Access Compliance Report

Public Rights-of-Way

(Curb Ramps)

Intersection ID: 30360	Main Street: TIMBERTOP_LN	Cross Street: WORLEY_DR	Location: NE
ADA ID: 3402A9DCA368	Ramp Type: PerpDiag	Initial Pass/Fail: Fail	Overall Compliance: No
		Severity Score: 22.5

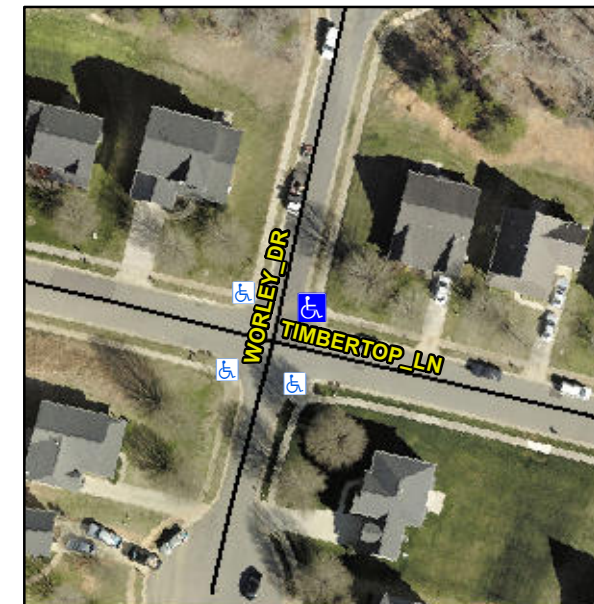
Not Found, R304.5.1, R304.2.2, R304.5.3

Compliance	Description	Data	Compliance	Description	Data
N/A	Ramp Length (in)	44.0	No	Ramp Slope (%)	9.3
No	Ramp Width (in)	47.5	No	Ramp XSlope (%)	4.0
N/A	Flare Type LT	N/A	N/A	Flare Type RT	N/A
N/A	Flare Slope LT (%)	N/A	N/A	Flare Slope RT (%)	N/A
N/A	Flare Traversable LT?	N/A	N/A	Flare Traversable RT?	N/A
N/A	Landing Length (in)	N/A	N/A	DWS Provided?	N/A
N/A	Landing Width (in)	N/A	N/A	DWS Contrast?	N/A
N/A	Landing Slope (%)	N/A	N/A	DWS Length (in)	N/A
N/A	Landing X Slope (%)	N/A	N/A	DWS Full Width?	N/A
N/A	Landing Curb? (Y/N)	N/A	N/A	DWS Offset (in)	N/A
N/A	Shared Landing?	N/A			
N/A	Gutter Ponding?	N/A	N/A	Gutter Slope (%)	N/A
N/A	Gutter Lip Ht (in)	N/A	N/A	Gutter X Slope (%)	N/A
N/A	Painted X Walk1?	No	N/A	Painted X Walk2?	No
	X Walk 1 Direction	To NW		X Walk 2 Direction	To SW
N/A	X Walk 1 Width (in)	N/A	N/A	X Walk 2 Width (in)	N/A
	X Walk 1 Slope (%)	5.8		X Walk 2 Slope (%)	6.6
	X Walk 1 X Slope (%)	0.4		X Walk 2 X Slope (%)	7.7

Remove & Replace Curb Ramp With Two New Directional Ramps or Equivalent.
